H11325

DESCRIPTIVE REPORT

Sublocality Vicinity of Lighthouse Rocks

Descriptive Report to Accompany Hydrographic Survey H11325

Figure 1. H11325 Survey Limits

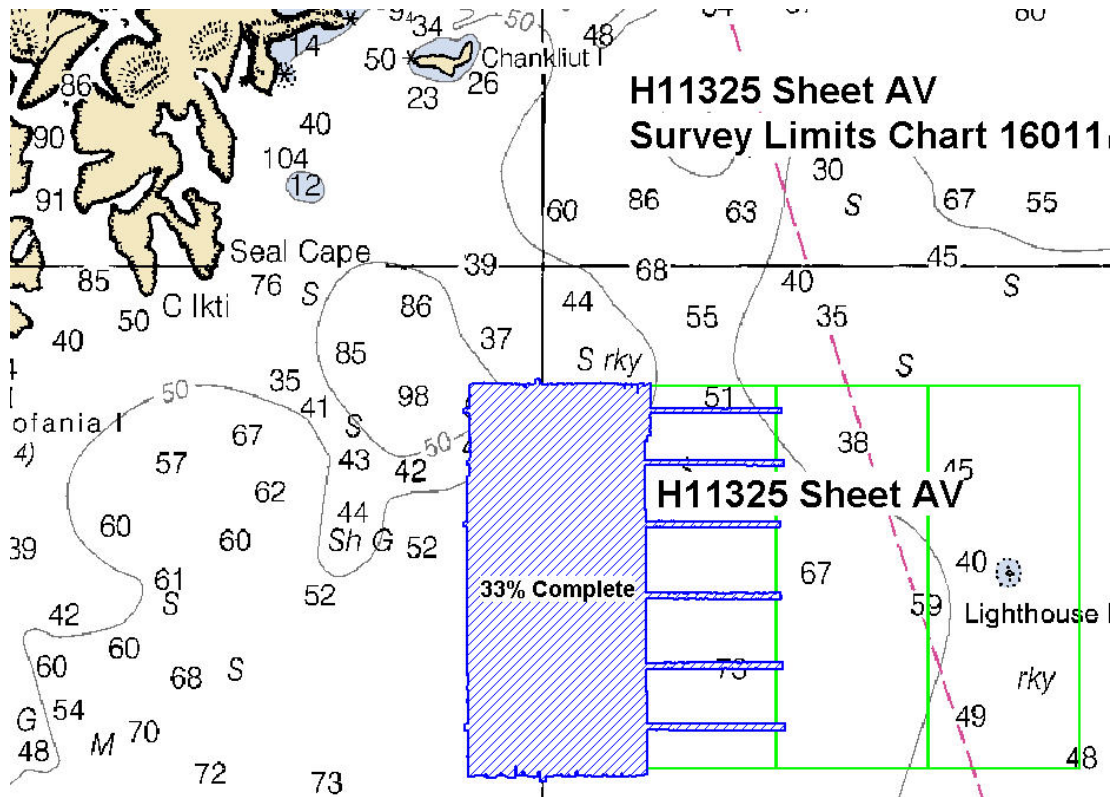
¹ Project Instructions set the survey scale at 1:40,000. The hydrographer received authorization to submit H11325 at 1:20,000 scale. The Field Number has been changed to RA-20-02-04. Due to spatial problems at this scale, the smooth sheet was created at 1:40,000 scale. For further information, see supplemental correspondence email dated 10 May 2005, attached to this report.
